1 - 33 Rossett House, Hull

Type 4 Fire Risk Assessment

Prepared for:	Rebecca Franks, Programme Manager
Prepared by:	John Askew, Fire Risk Assessor, Holistic Fire Safety
Date Submitted:	25/04/2026
Document Reference:	HFS.HCC.RossettHouse.FRA.2.0

Photo 69

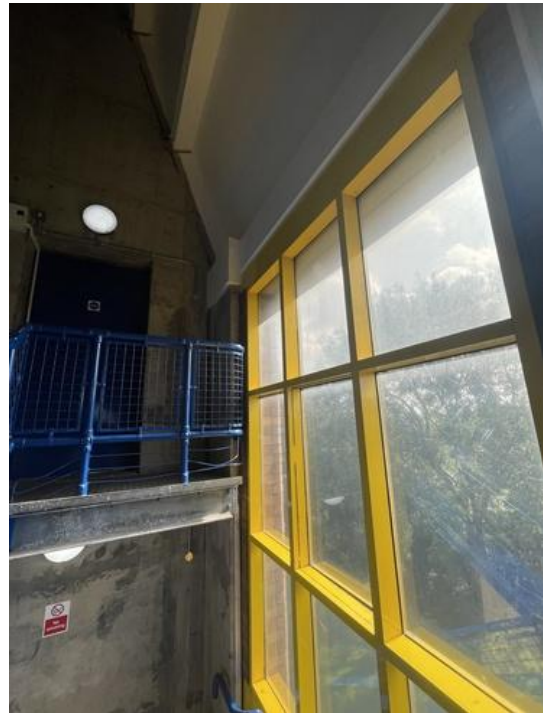
There is no ventilation provided to the escape stairway to the south of the building accessed from the third floor.

Limited ventilation can be achieved on the fourth floor at low level by openable windows however, it was noted most of these were screwed shut or seized.

There is no ventilation provided to the fifth floor stairway to the north of the building.

Current guidance states that vents in lobbies or corridors adjoining stairways should be operated automatically, however the installation of Automatic Opening Vent (AOV's) are not considered reasonably practicable. Although current openings do not provide a minimum free area of 1.5 metres squared (m²) to the fourth floor, current provisions are considered adequate given other mitigation measures in place and that maintenance is carried out to release seized windows and remove screws.

Protected stairways also need means to ventilate any smoke that may enter the stairway during evacuation or fire fighting and allow a route for air to reach ventilated lobbies. A vent of at least 1m² needs to be provided at the head of the stairway for this. Current guidance states that in blocks of flats with a single stairway, it is recommended that the vent is operated automatically via an AOV.

It is not considered reasonably practicable to provide ventilation in the stairway to the north of the building however, consideration should be given to providing ventilation in the stairway to the south of the building which is accessed from the third floor.

Carry out maintenance to release seized windows and remove screws.

Provide ventilation to the south stairway. This could be achieved by providing a Manual Opening Vent (MOV) alternatively, ventilation could be achieved by installing low level and high level louvered vents.

Photo 105

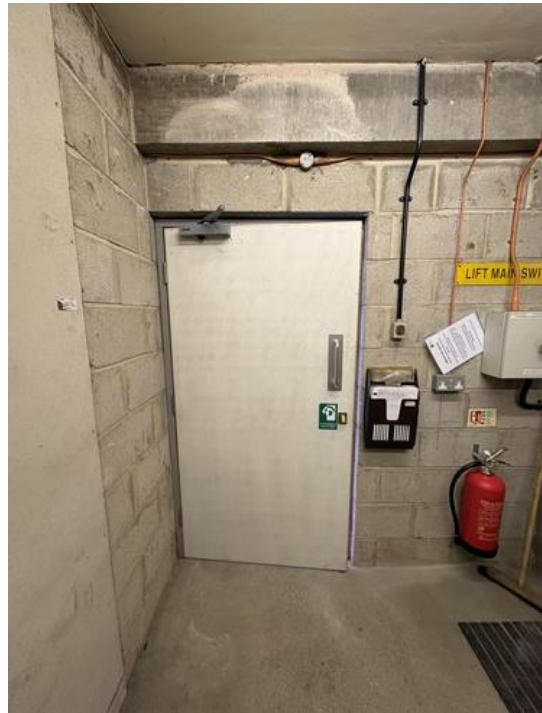
Internal refuse chutes are separated by a mixture of metal and timber self-closing, notional FD30 fire doorsets, which are considered to be in good condition. Metal doorsets have none-fire-rated glazed apertures at upper levels and panelling to the lower parts. It could not be confirmed if the panels are of fire-resistant material.

Ancillary accommodation doors are notional 44mm FD30s doorsets and have been subject to remediation. Doors are fitted with x3 100mm BS 1935 Grade 13 CE marked hinges and single strip combination cold smoke and intumescent seals fitted into the leaf. Gaps between leaf and frame are generally not more than 3mm top and side rails; however, there are variations to this and gaps at the bottom threshold where >8mm have had drop-down seals fitted. BSEN 1154 CE marked self-closing devices are fitted where necessary.

The lift motor room door has not been remediated and is fitted with three non-fire-rated hinges that are heavily painted, and intumescent strips that are also heavily painted. Gaps were observed to be in excess of acceptable tolerances.

Carry out remediation to the lift motor room door.
